WMA- J.D. Murphree, Port Arthur TX, ADA Evaluation

Accessibility Evaluation

Inspection Date: 07/19/2022

Report Date: 01/18/2024

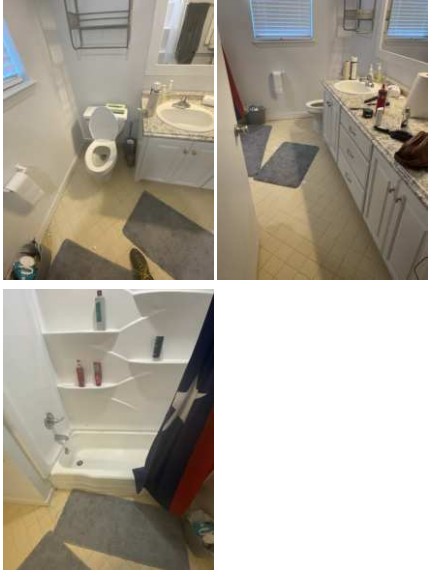
18	Structures on Property (Public) : Bunk Areas (Interior)	Minimum maneuvering clearances at doors and gates shall comply with 404.2.4. Maneuvering clearances shall extend the full width of the doorway and the required latch side or hinge side clearance. Maneuvering clearances shall have a max slope of 2.08%. Door openings shall provide a clear width of 32 inches (815 mm) minimum. Clear openings of doorways with swinging doors shall be measured between the face of the door and the stop, with the door open 90 degrees. Openings more than 24 inches (610 mm) deep shall provide a clear opening of 36 inches (915 mm) minimum. There shall be no projections into the required clear opening width lower than 34 inches (865 mm) above the finish floor or ground. Projections into	Bunk Area More than 60% doors/entrances are equipped with non-compliant hardware. Most doorway thresholds in exceed 1/2" tolerance.	Review door and threshold componets to make accessible https://www.access-board.gov/ada/#ada-404	2010 ADAS Section: 404.2.3, 404.2.7, 404.2.4, 404.2.11, 404.2.11 Exception

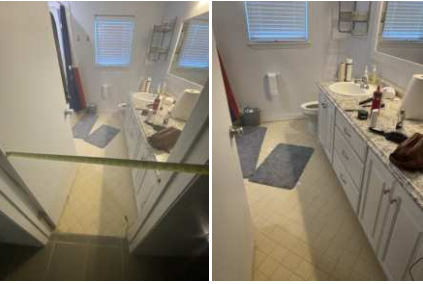
Finding Number	Area Description	Finding	As Built	Recommendation	Citation	Photos	Figure
		<p>the clear opening width between 34 inches (865 mm) and 80 inches (2030 mm) above the finish floor or ground shall not exceed 4 inches (100 mm). The threshold has a vertical change greater than 1/4 inch high. The threshold has a gap greater than 1/2 inch wide. The threshold at a doorway shall be no higher than 1/2 inch. Changes in level between 1/4 inch and 1/2 inch must be beveled at 1:2 or less. 1/4 inch is the maximum vertical rise. All interior doors must be maintained so that the operating pressure does not exceed 5 lbf to open. The sweep period for doors with closers shall be adjusted so that from an open position of 70 degrees, the door will take at least 3 seconds to move to a point 3 inches from the latch, measured to the leading edge of the door. Exterior doors are recommended to be maintained at 8.5 lbf as a smart practice. Force is to be measured at the operating hardware or 30 inches from the hinges, whichever is greater. Hand-activated door opening hardware, handles, pulls, latches, locks, and other operating devices on accessible doors shall have a shape that is easy to grasp with one hand and does not require tight grasping, tight pinching or twisting of the wrist to operate. Hardware shall be 34 inches minimum and 48 inches maximum above the finish floor or ground. The bottom 10 inches on the push side must be smooth and free of obstructions (hold open devices). Doors, gates, and side lights adjacent to doors or gates, containing one or more glazing panels that permit viewing through the panels shall have the bottom of at least one glazed panel located 43 inches (1090 mm) maximum above the finish floor. EXCEPTION: Vision lights with the lowest part more than 66 inches (1675 mm) from the finish floor or ground shall not be required to comply with 404.2.11. Egress doors shall provide a continuous and unobstructed way of egress travel from any point in a building or facility that provides an accessible route to an area of refuge, a horizontal exit, or a public way.</p>

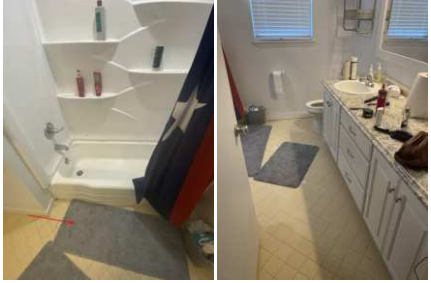
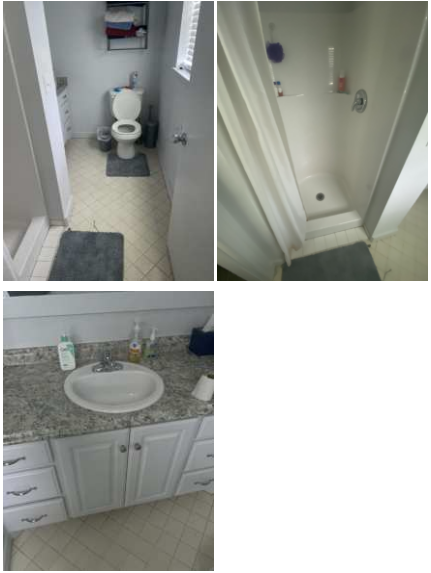
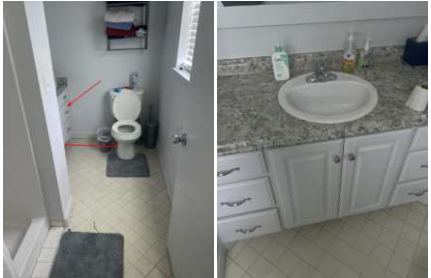
Finding Number	Area Description	Finding	As Built	Recommendation	Citation	Photos	Figure
19	Structures on Property (Public) : Bunk Areas (Interior) - Entrance Doors	The door is equipped with a door closer and returns to a closed position too quickly. Door closers and gate closers shall be adjusted so that from an open position of 90 degrees, the time required to move the door to a position of 12 degrees from the latch is 5 seconds minimum.	Screen door closes to fast. screen or storm doors are not considered "doors in series" since they are part of the same doorway opening as the entry door. They are not prohibited by the Standards but must meet all applicable requirements for doors except those pertaining to doors in series.	https://www.access-board.gov/ada/#ada-404_2_8_1	2012 TAS Section: 404.2.8.1 2010 ADAS Section: 404.2.8.1 2015 ABAAS Section: 404.2.8.1		
20	Structures on Property (Public) : Bunk Areas (Interior) - Entrance Doors	The operating hardware requires tight grasping, pinching or twisting of the wrist to operate. Hand-activated hardware, handles, pulls, latches, locks, and other operating devices on accessible elements shall have a shape that is easy to grasp with one hand and does not require tight grasping, pinching or twisting of the wrist to operate.	Door hardware and locking mechanisms are not compliant.	https://www.access-board.gov/ada/#ada-309_4	2012 TAS Section: 309.4 2010 ADAS Section: 309.4 2015 ABAAS Section: 309.4

21	Structures on Property (Public) : Bunk Areas (Interior) - Entrance Doors	The threshold has a vertical change greater than 1/4 inch. The threshold at a doorway shall be no higher than 1/2 inch. Changes in level between 1/4 inch and 1/2 inch must be beveled at 1:2 or less. The maximum vertical rise shall be 1/4 inch.	Threshold exceeds 1/2"	https://www.access-board.gov/ada/#ada-404_2_5	2012 TAS Section: 404.2.5 2010 ADAS Section: 404.2.5 2015 ABAAS Section: 404.2.5

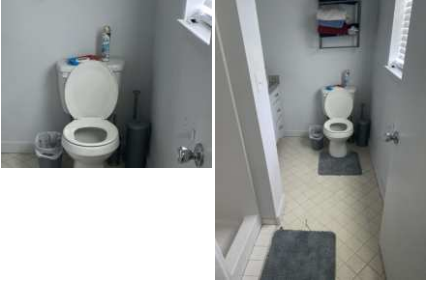
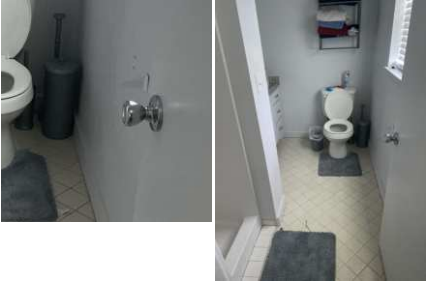
Finding Number	Area Description	Finding	As Built	Recommendation	Citation	Photos	Figure
22	Structures on Property (Public) : Bunk Areas (Interior) - Entrance Doors	The floor mat at the door is not secured in place. If carpet or carpet tile is used on a ground or floor surface, then it shall be securely attached; have a firm cushion, pad or backing or no cushion or pad; and have a level loop, textured loop, level-cut pile or level-cut/uncut pile texture. The maximum pile height shall be 1/2 inch. Exposed edges of carpet shall be fastened to floor surfaces and have trim along the entire length of the exposed edge. Recessed doormats shall be adequately anchored to prevent interference with wheelchair traffic.	This style door mat is not of compliant size or durability and does not meet compliance.	https://www.access-board.gov/ada/#ada-302_2	2012 TAS Section: 302.2 2010 ADAS Section: 302.2 2015 ABAAS Section: 302.2

23	Structures on Property (Public) : Bunk Areas (Interior) - Entrance Doors	The vision light panels (glazing/window) exceed height requirements. Doors, gates, and side lights adjacent to doors or gates, containing one or more glazing panels that permit viewing through the panels shall have the bottom of at least one glazed panel located 43 inches maximum above the finish floor.	Interior doorway	https://www.access-board.gov/ada/#ada-404_2_11	2012 TAS Section: 404.2.11 2010 ADAS Section: 404.2.11 2015 ABAAS Section: 404.2.11

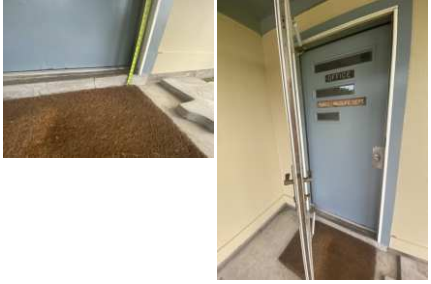
34	Structures on Property (Public) : Bunk Areas (Interior) - Restroom #2 Rear of Bunk House (Unisex)	The restroom is not nearly compliant. The restroom does not have the required minimum clear floor space or maneuvering clearances for the toilet. The restroom does not have the required minimum clear floor space or maneuvering clearances for the lavatory. The entry door does not contain the required minimum maneuvering spaces on the pull/push sides. The entry door encroaches into the required clear floor space for fixtures. Grab bars are missing and/or incorrectly installed. Accessories, such as toilet seat covers, paper towel holders, garbage cans, hand dryers, and mirrors are either too high or without clear floor space or both. The restroom contains floor level changes greater than a 1/2 inch of the floor drains and is slope (XX) - (XX), the shower is too small and missing numerous accessible elements.	This restroom requires a number of components to gain compliance.	https://www.access-board.gov/ada/#ada-213_2 Review restroom components to make accessible. https://www.access-board.gov/ada/#ada-603	2012 TAS Section: 213.2 2010 ADAS Section: 213.2 2015 ABAAS Section: F213.2

35	Structures on Property (Public) : Bunk Areas (Interior) - Restroom #2 Rear of Bunk House (Unisex)	There are not enough accessible lavatories. Where lavatories are provided, at least one shall be accessible and shall not be located in a toilet compartment.	The lavatory and accessories are not compliant. There is not enough clear floor space to access lavatory. Restrooms are required to provide front approach with knee and toe space.	https://www.access-board.gov/ada/#ada-213_3_4 Review lavatory components to make accessible. https://www.access-board.gov/ada/#ada-606	2012 TAS Section: 213.3.4 2010 ADAS Section: 213.3.4 2015 ABAAS Section: F213.3.4
